METROPOLITAN GOVERNMENT OF NASHVILLE AND DAVIDSON COUNTY

STAFF RECOMMENDATION 1809 Sweetbriar Avenue June 20, 2012

Application: Infill and Accessory structure
District: Belmont-Hillsboro Neighborhood Conservation Zoning Overlay
Council District: 18
Map and Parcel Number: 11704006000
Applicant: Brent Craig, Rigid Development
Project Lead: Melissa Baldock, melissa.baldock@nashville.gov

Description of Project: The applicant is proposing to construct a new one-and-half-story house and a two-story accessory structure on a vacant lot.

PLOT PLAN

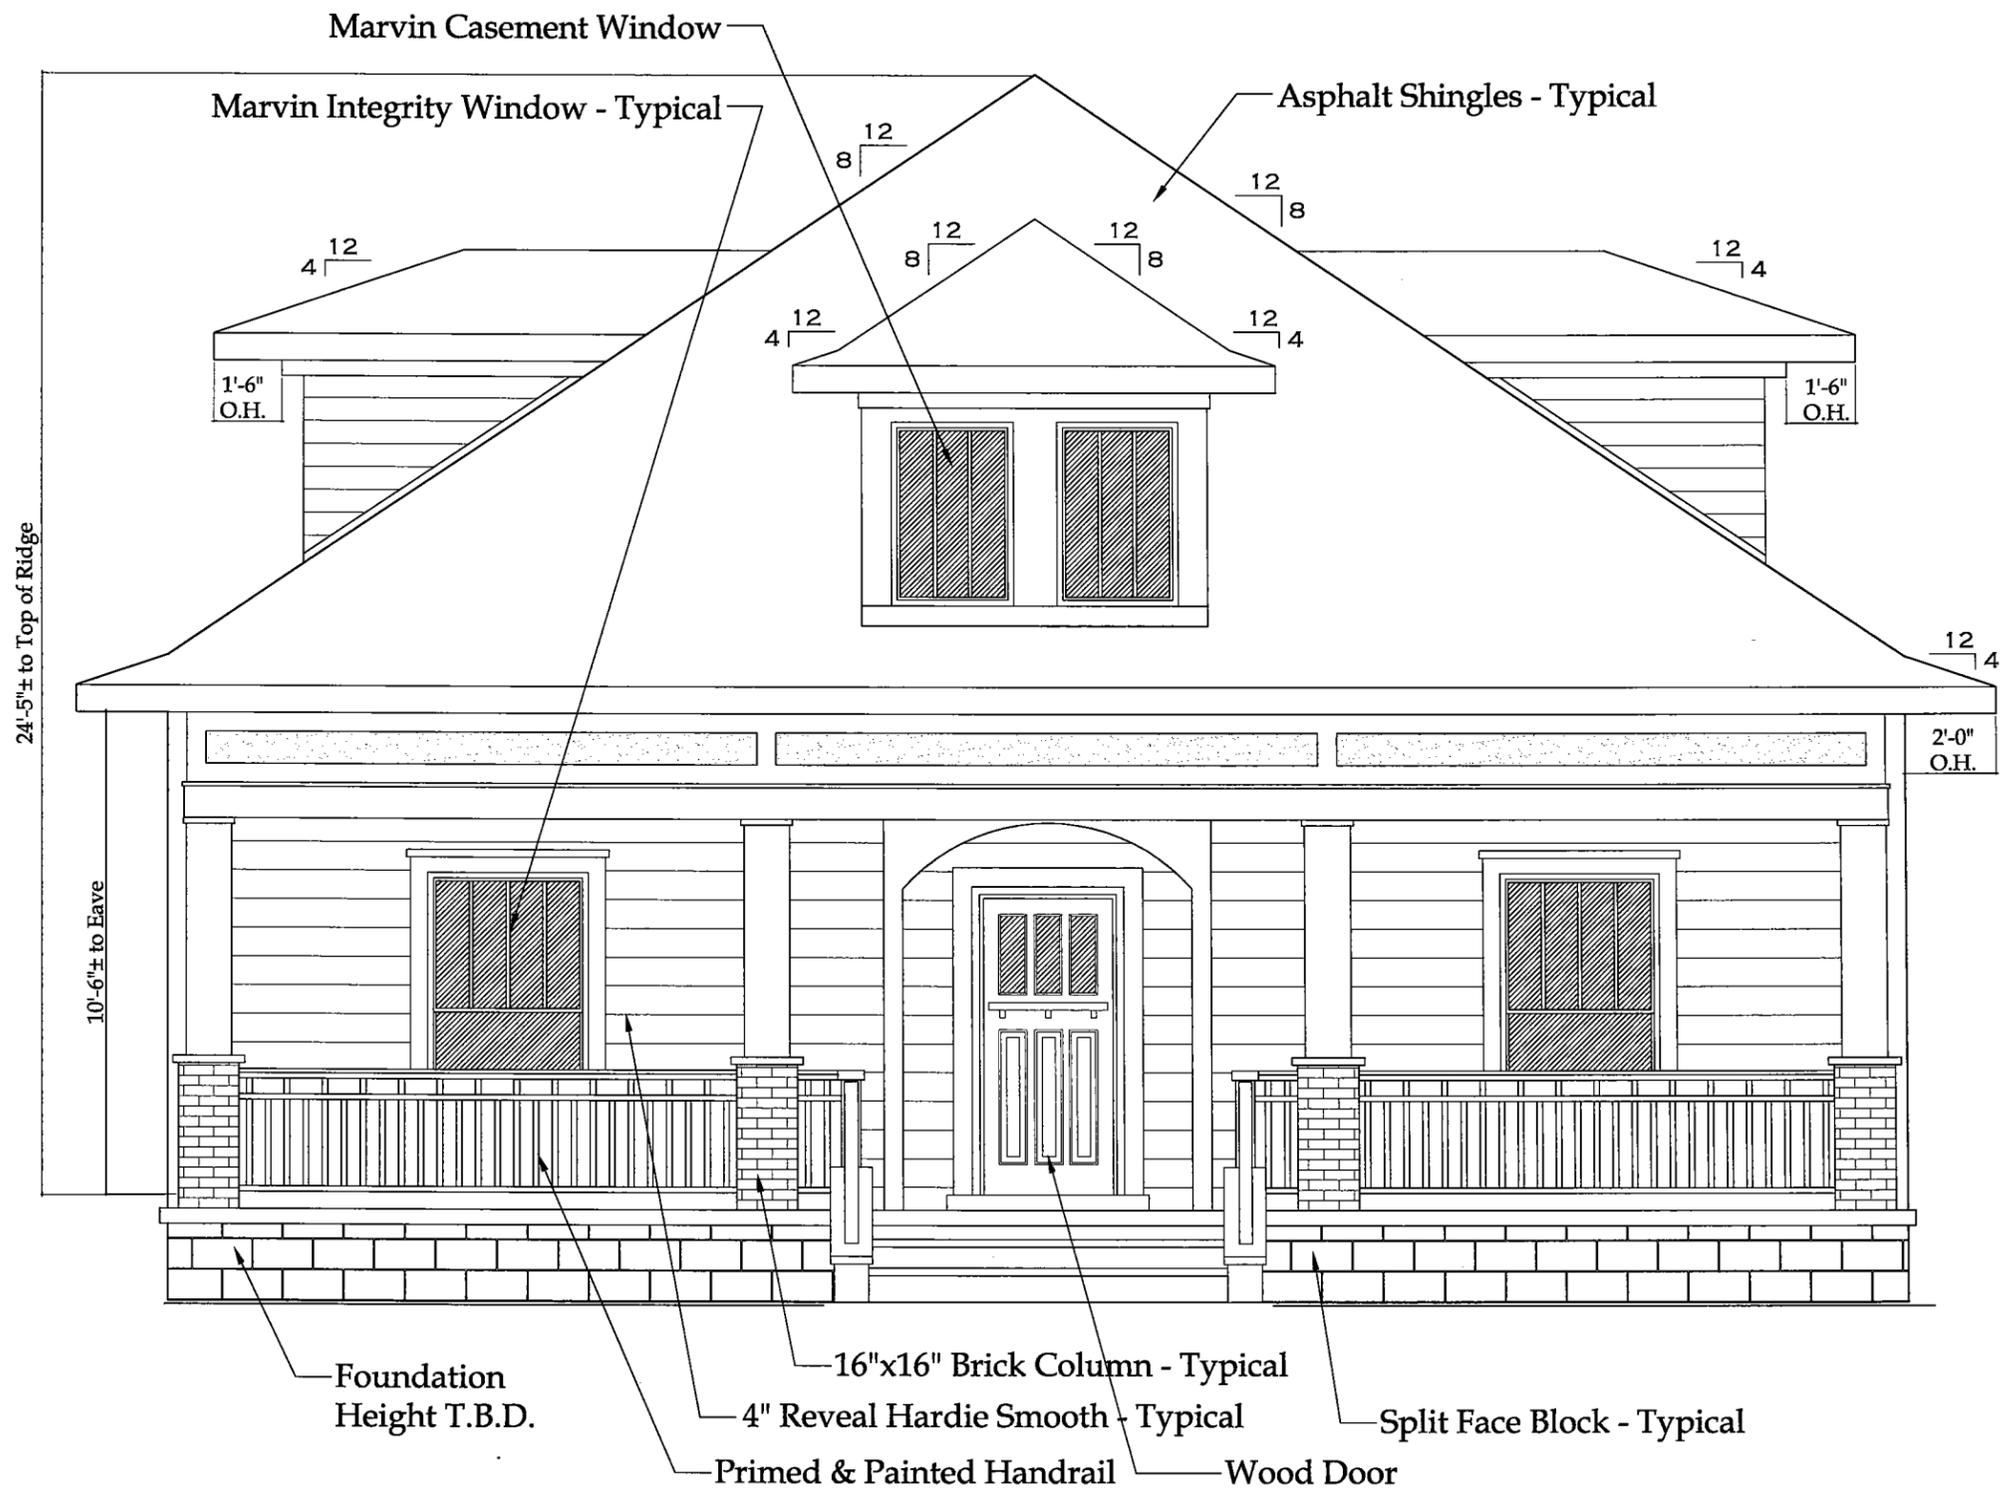
The appropriateness of the height of the proposed structure should be contingent, however, on staff receiving and reviewing revised drawings that accurately portray the slope of the site and the height of the foundation along the slope. The submitted drawings assume the lot is flat, but in reality there is a considerable drop from right to left on the site. On historic houses where the lot slopes from side to side, typically the foundation at the highest corner of the site will be one course of stone or block, and the foundation will get taller as the grade drops. With the staff's approval of revised drawings that show the existing grade and the foundation height, staff finds the infill's height to be appropriate.

Orientation: The proposed infill has a full width front porch and centered primary entrance. The infill faces Sweetbriar Avenue, as do all the other buildings on this block. No walkway was indicated, and staff recommends that a central walkway leading from the sidewalk to the front porch be added to the site. With the addition of a central sidewalk, staff finds the orientation to meet Section II.B.1.f of the *Belmont-Hillsboro Neighborhood Conservation Zoning Overlay Handbook and Design Guidelines*.

1. The applicant submit new drawings indicating how the grade will be addressed in the new construction, particularly as it relates to the infill's foundation line, the overall height of the house, and the relationship of the height of the accessory structure to the height of the house.

6. A central walkway running from the sidewalk to the porch be added.
7. Utilities be located in the rear or on a side façade, beyond the house's midpoint.

Front Elevation
 Issued: 1 June 2012

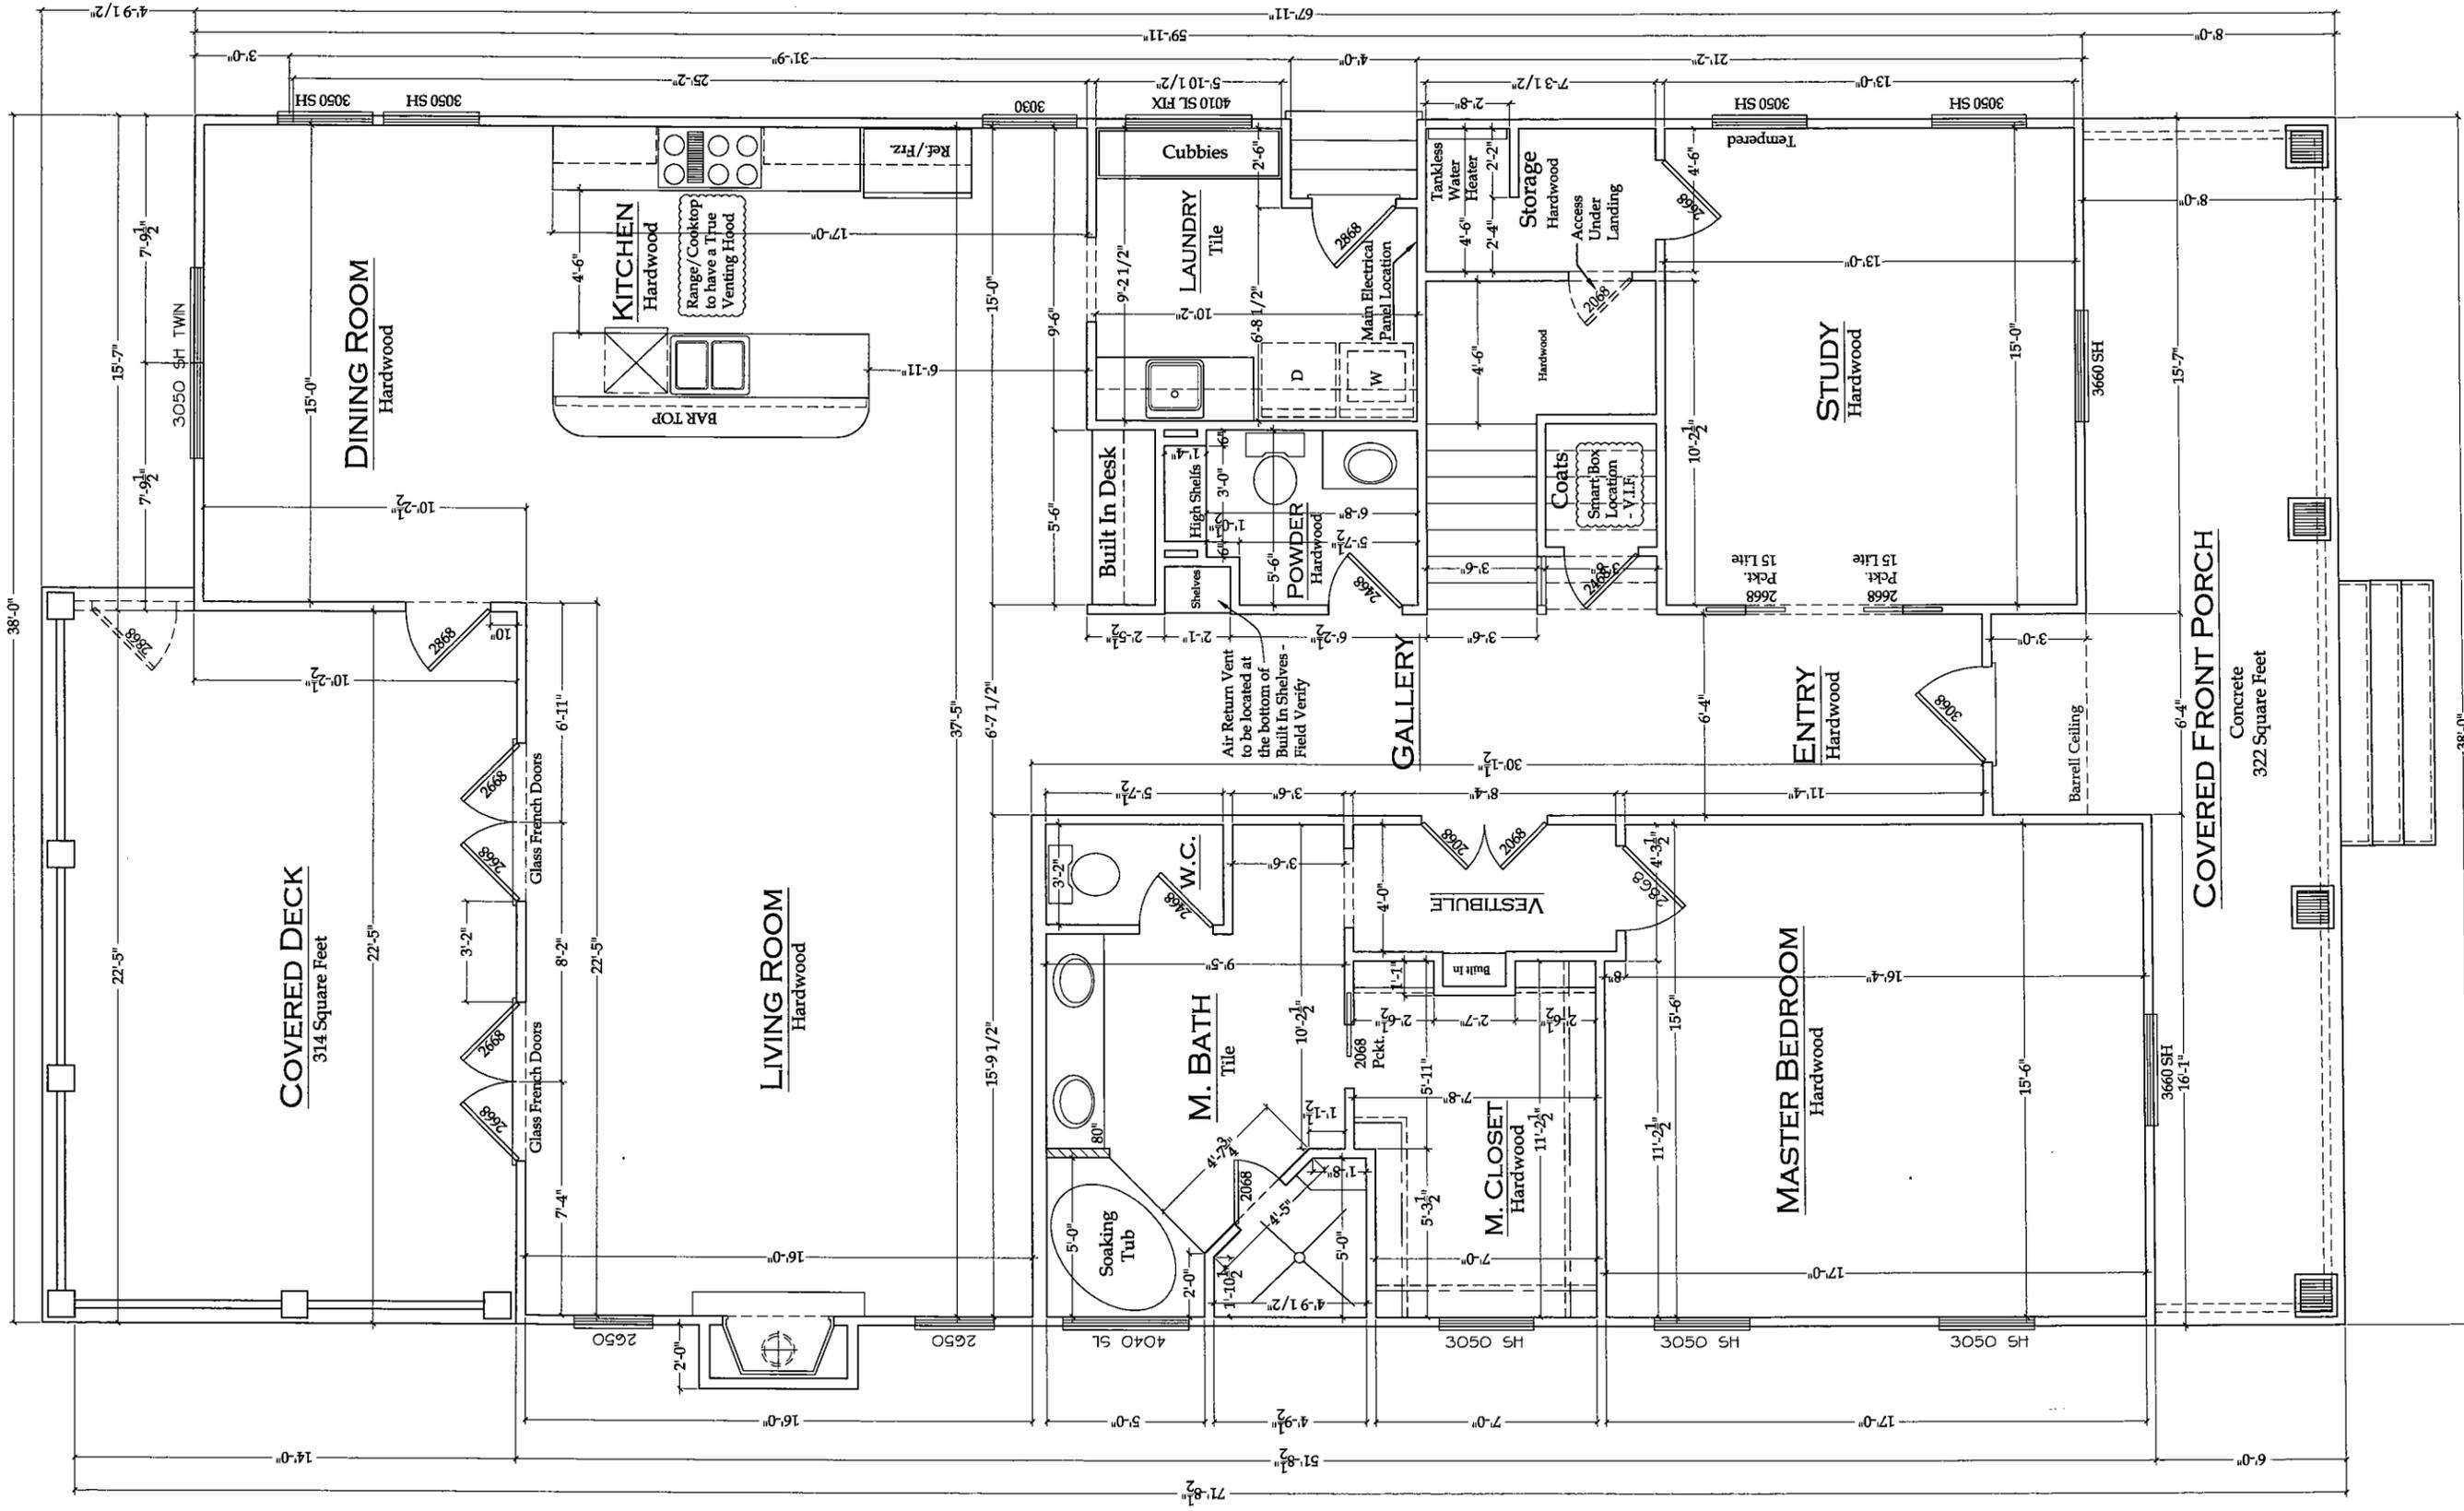
Roof: The infill's primary roof form will be a hipped roof with a slope of 8/12; the edge of the roof flares with a 4/12 slope. The front dormer will also have a hipped roof with an 8/12 slope and a 4/12 flare. The front dormer is proposed to sit one foot (1') from the porch rack. Staff asks that a condition of approval be that the dormer be inset an additional foot so that it is set back two feet (2') from the porch rack.

4. The rear porch columns have a cap and a base.
5. The front wall of the front dormer be pushed back to be two feet (2') from the line of the porch rack.
